Technical Service Bulletin

MODEL(S) AFFECTED: Tennant T1, T1B, E5 and R3

SUBJECT: Recovery tank ball-float filter prematurely activates and/or machine has poor vacuum suction. This may be caused by the motor shroud not being positioned properly.

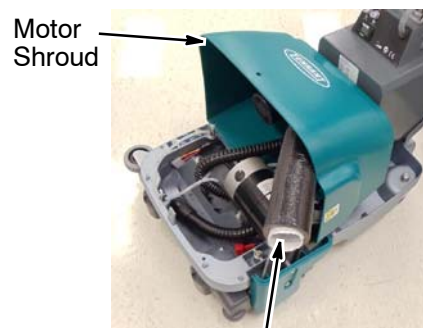
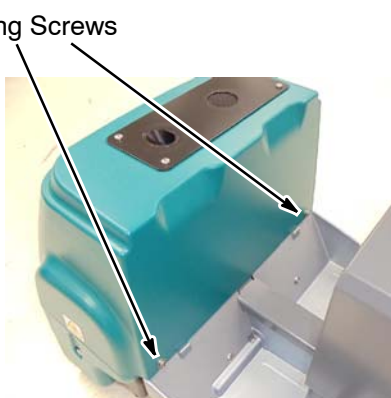
PURPOSE: If motor shroud is slightly raised as shown below, the tank gaskets will not form the proper seal with the solution tanks when cover is lowered.

Shroud not properly seated.
Gap can be as little as 1/16"
(1.5 mm).

When replacing motor shroud, make sure the shroud is completely resting on the frame. The vacuum exhaust muffler may prevent cover from being completely lowered. Before tightening screws, apply downward pressure on shroud to ensure proper installation.

Shroud properly seated.
